# UNITED STATES PATENT AND TRADEMARK OFFICE

APPLICATION NO.	FILING DATE	FIRST NAMED INVENTOR	ATTORNEY DOCKET NO.	CONFIRMATION NO.
09/918,886	07/30/2001	Ting K. Yee	20852-05682	3294

**Office Action Summary**

## DETAILED ACTION

FIG. 16

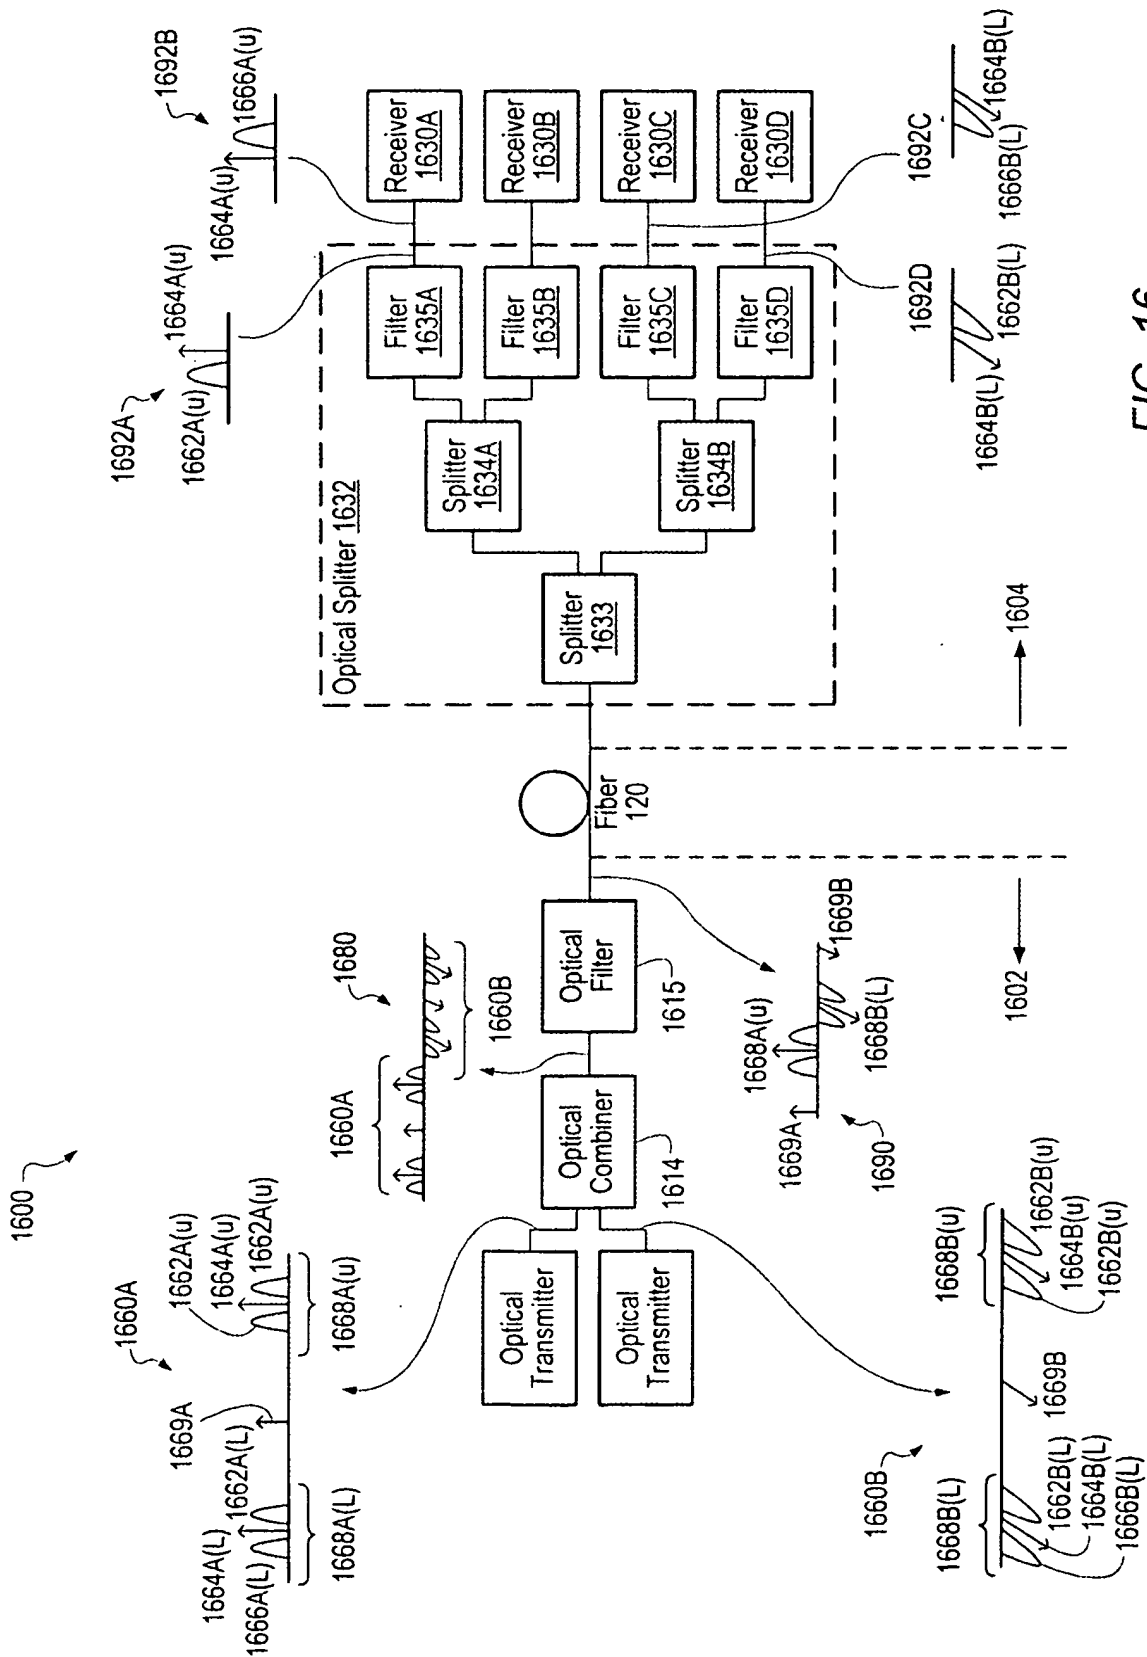
In Fig. 16, label the upper optical transmitter with “1610A” as in old Fig. 16 filed on 30 July 2001. Also, label the lower optical transmitter with “1610B” as in old Fig. 16 filed on 30 July 2001. Otherwise, the reference character “1610” in paragraphs [0043, 0047, 0050, 0054] is not in the figures. Also, see paragraph [0108] for support.

In Fig. 16, replace the rightmost “1662A(u)” with “1666A(u)” as shown in old Fig. 16 filed on 30 July 2001. See paragraph [0109] for support.

In Fig. 16, replace the rightmost “1662B(u)” with “1666B(u)” as shown in old Fig. 16 filed on 30 July 2001. See paragraph [0110] for support.

In Fig. 16, extend the lead line for spectrum 1692B to the input line for receiver 1630B. Otherwise, Fig. 16 shows spectrum 1692A and 1692B for the input line to receiver 1630A.

FIG. 17

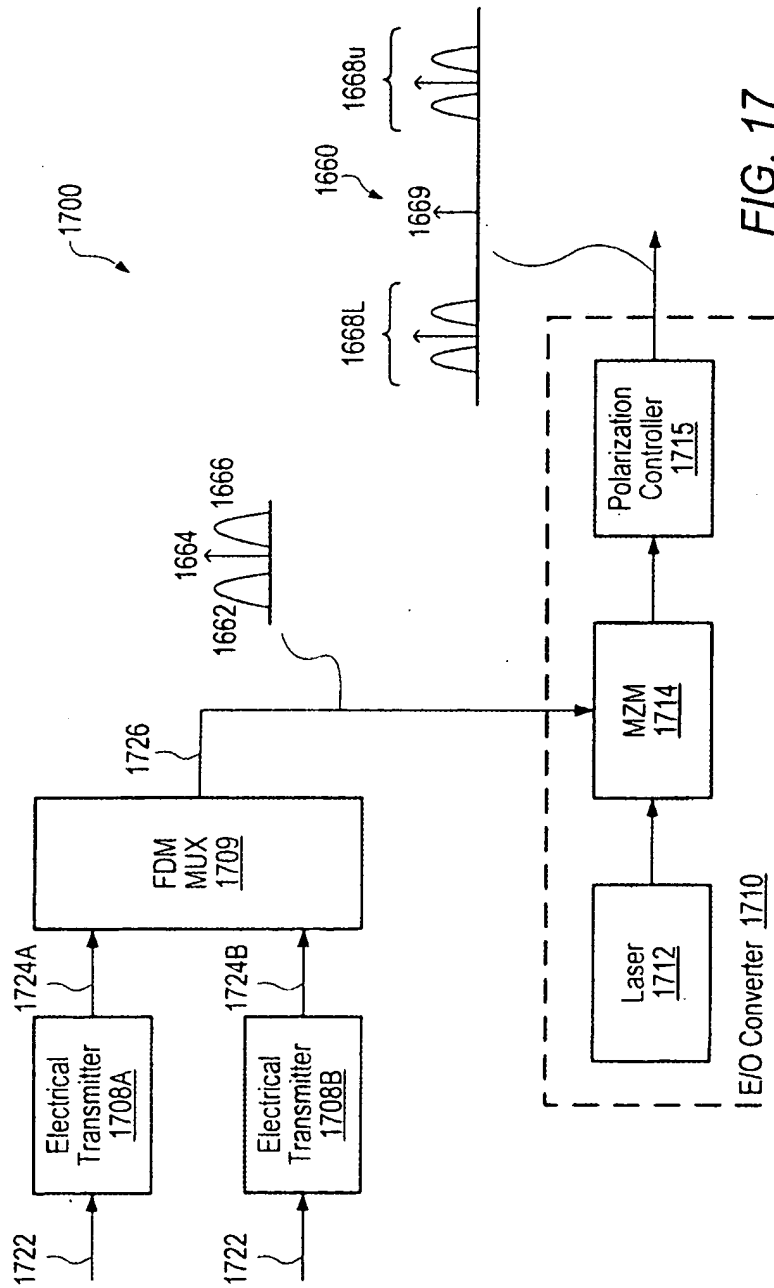
In Fig. 17, remove reference character “1700” and its lead line since it does not appear in the specification.

FIG. 18A

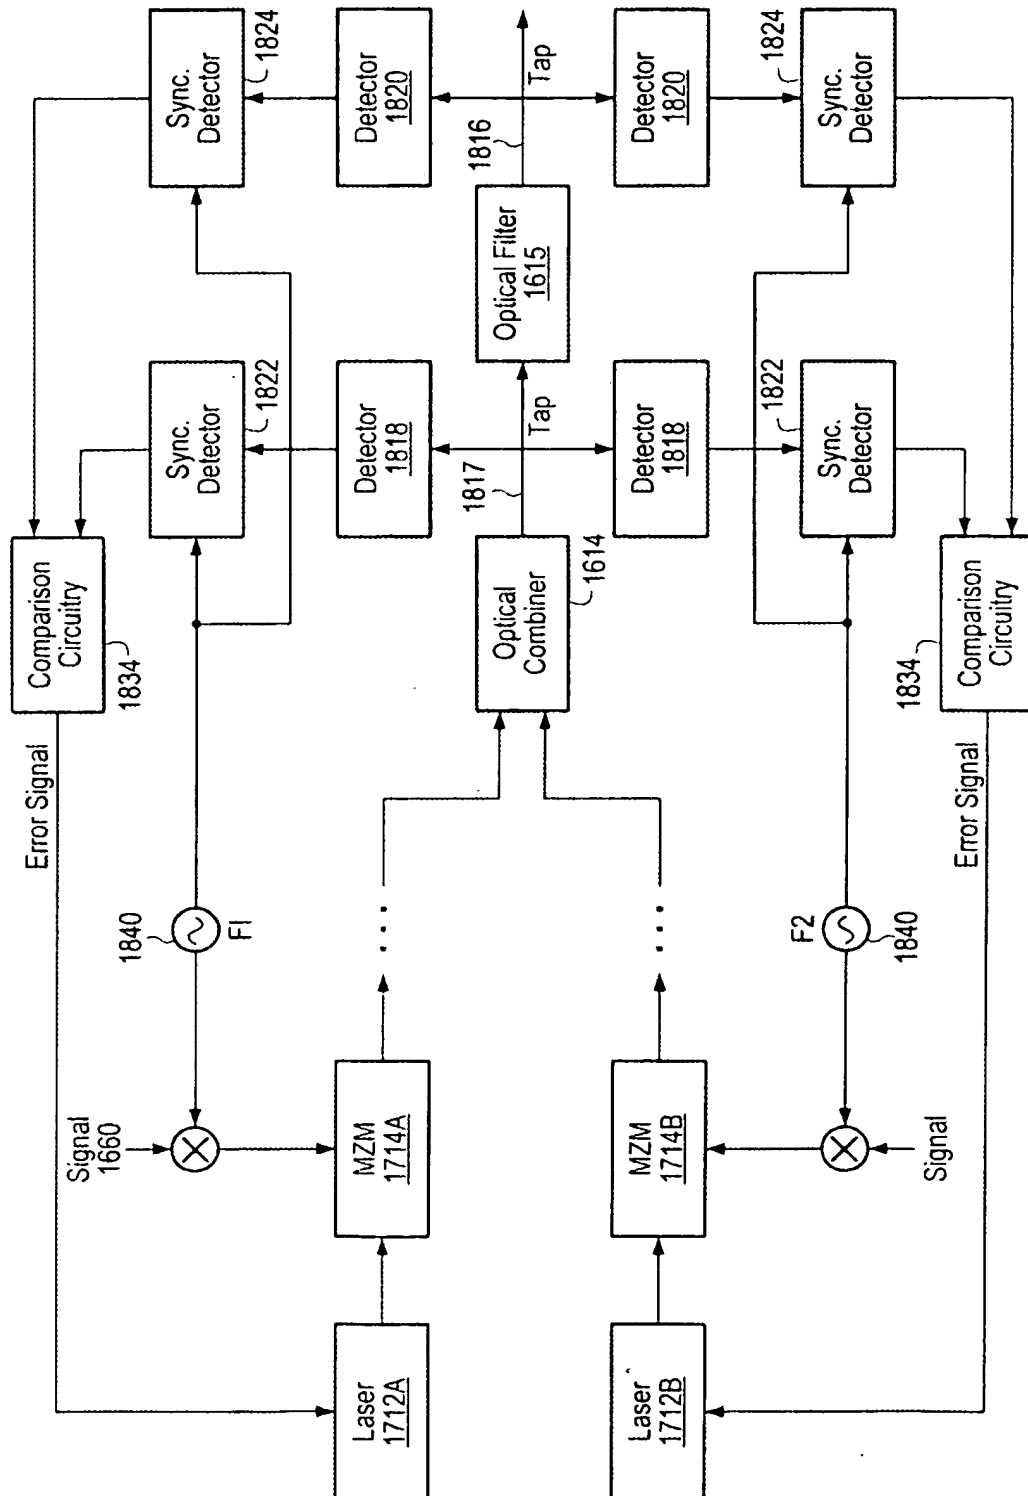
Applicant responded to the drawing objection regarding **claim 13** by amending Fig. 18A to show all of the features recited in claim 13. However, amended Fig. 18A is disapproved. In Fig. 18A, much of the bottom half is not supported by the specification and constitutes new matter. For example, the original disclosure does not disclose the bottom detectors 1818 and 1820, the bottom sync detectors 1822 and 1824, the bottom comparison circuitry 1834, and the associated connections. Rather, Fig. E-23B in provisional application 60/265,251 supports just one detector 1818, one detector 1820, one sync detector 1822, one sync detector 1824, one comparison circuitry 1834, and the associated connections. Accordingly, the drawing objection to claim 13 remains. The drawings remain objected to under 37 CFR 1.83(a). The drawings must show every feature of the invention specified in claim 13. No new matter should be entered. As a remedy, Examiner respectfully suggests amending Fig. 18A to correspond more closely to supported Fig. E-23B in provisional application 60/265,251.

In Fig. 18A, add a reference character “1800” that points to the entire device. See paragraphs [0044-0045, 0126] for support.

In Fig. 18A, much of the bottom half is not supported by the specification and constitutes new matter. For example, the original disclosure does not disclose the bottom detectors 1818 and 1820, the bottom sync detectors 1822 and 1824, the bottom comparison circuitry 1834, and the associated connections. Rather, Fig. E-23B in provisional application 60/265,251 supports just one detector 1818, one detector 1820, one sync detector 1822, one sync detector 1824, one comparison circuitry 1834, and the associated connections. Amend Fig. 18A to correspond more closely to supported Fig. E-23B in provisional application 60/265,251.

FIG. 18B

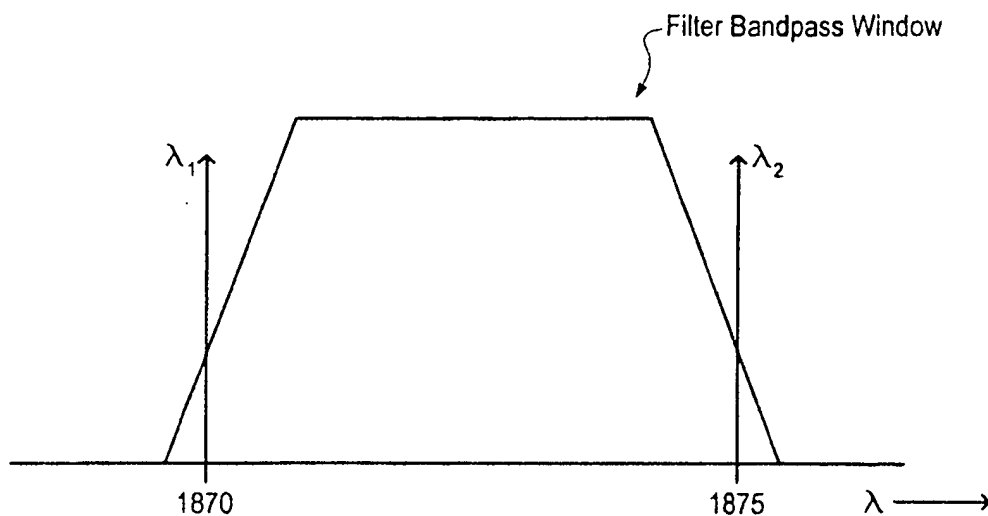
However, paragraphs [0131-0132] teach the use of a ratio for **each** optical signal. Fig. 18B shows multiple (2) signals, each signal requiring the use of its own associated ratio. The disclosure does not

support the use of just one ratio to lock the frequency separation between multiple optical signals.

Accordingly, claim 61 introduces new matter.

“...wherein the wavelength-locking device is coupled to the first optical tap and to the second optical tap and configured to lock the frequency separation based on a multiple ratios of the portions tapped by the optical taps.”

FIG. 22

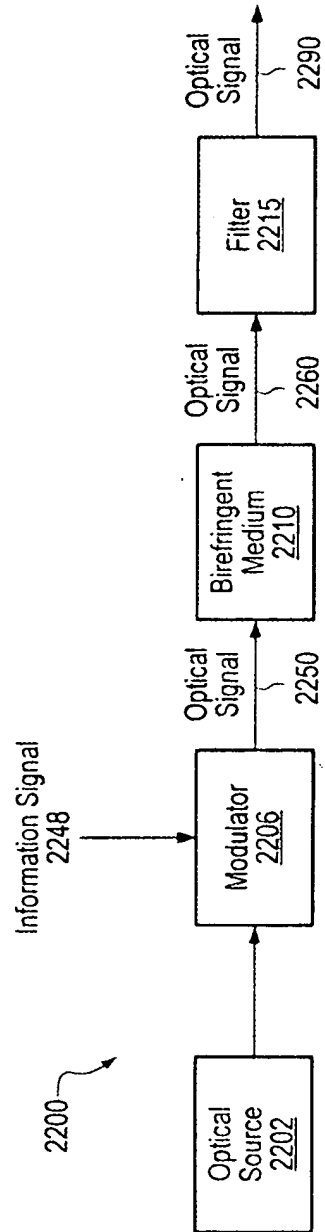
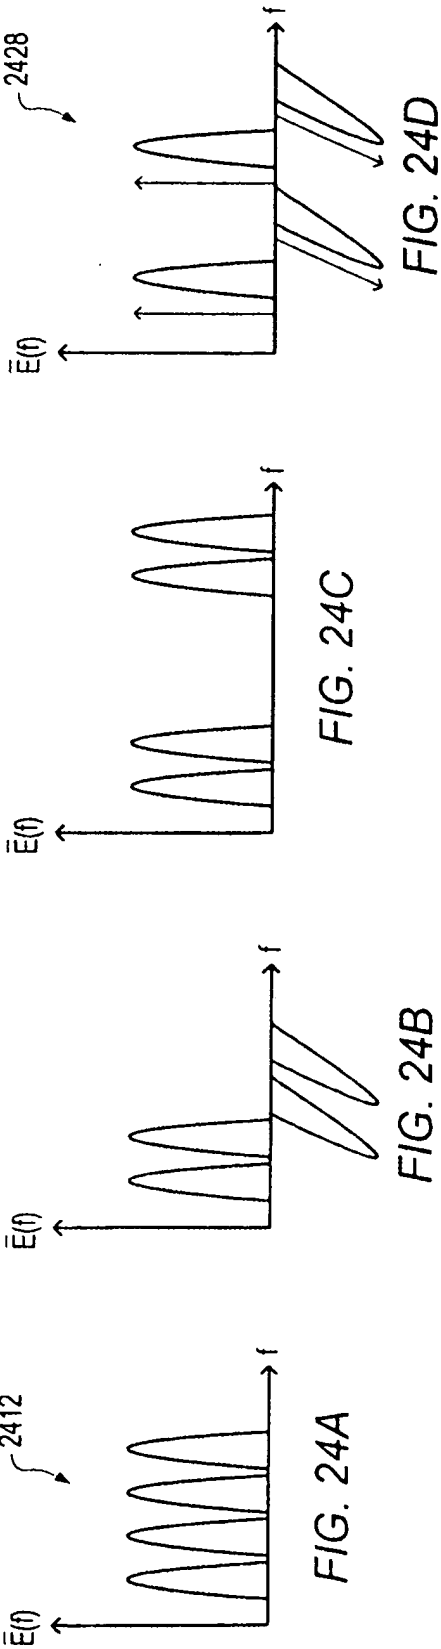
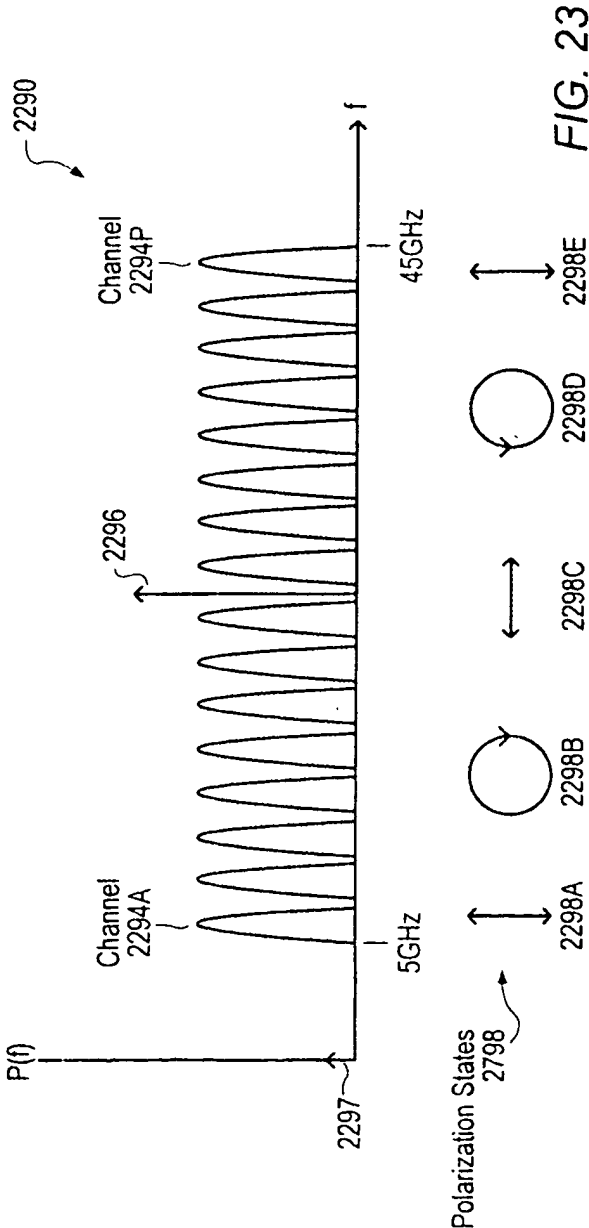
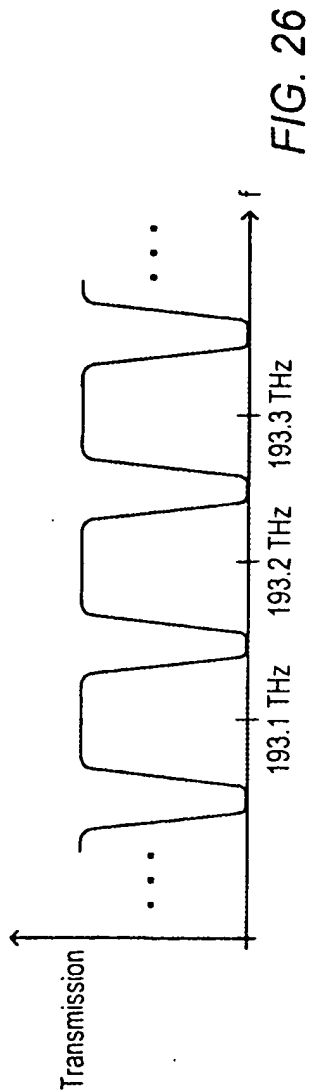
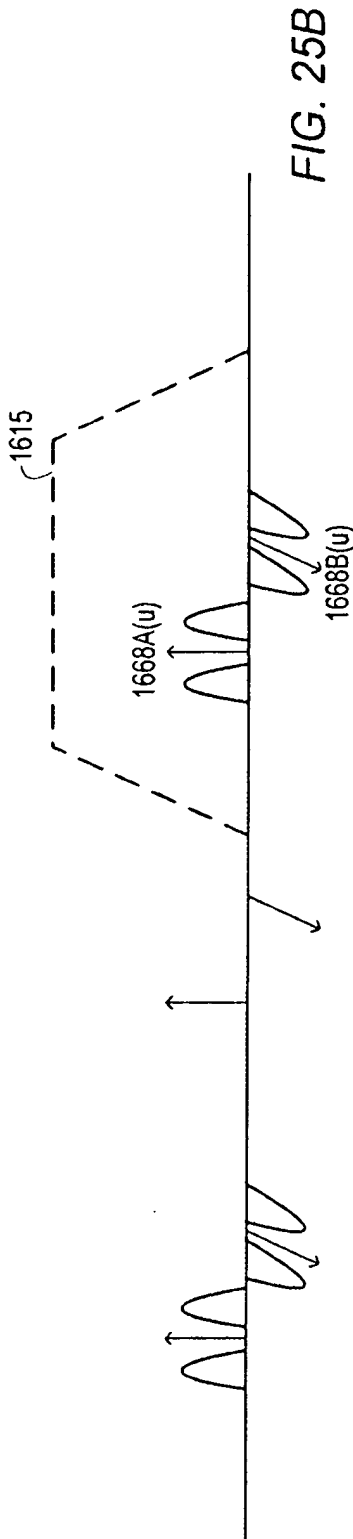
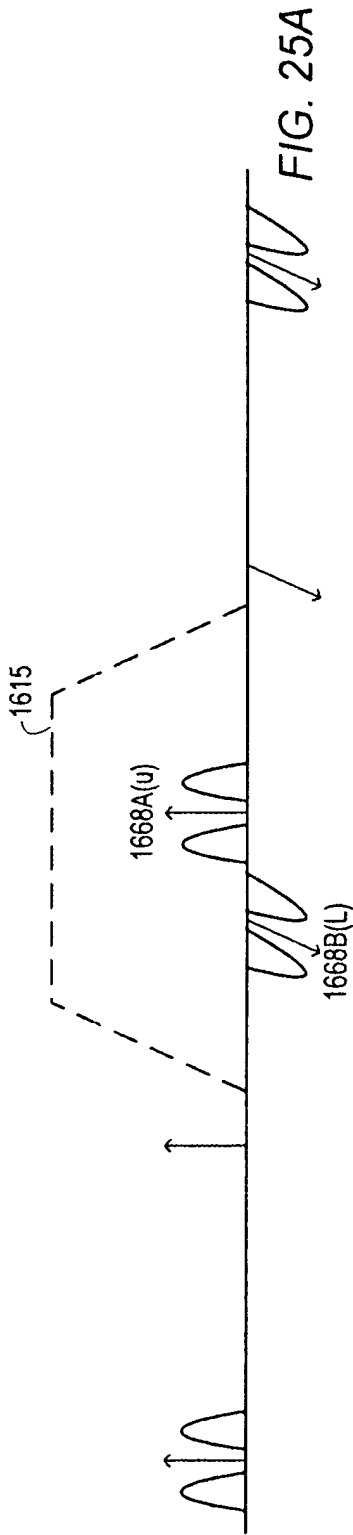
Applicant responded to the drawing objection regarding **claim 5** by pointing to Fig. 22 as support for the claim language in claim 5. However, Fig. 22 is directed to non-elected Species II (designated in an Office Action mailed on 03 November 2004). Accordingly, the drawing objection to claim 5 remains. The

drawings remain objected to under 37 CFR 1.83(a). The drawings must show every feature of the invention specified in claim 5. No new matter should be entered. As a remedy, Examiner respectfully suggests the submission of a new figure showing the limitations of claim 5 or the cancellation of claim 5.
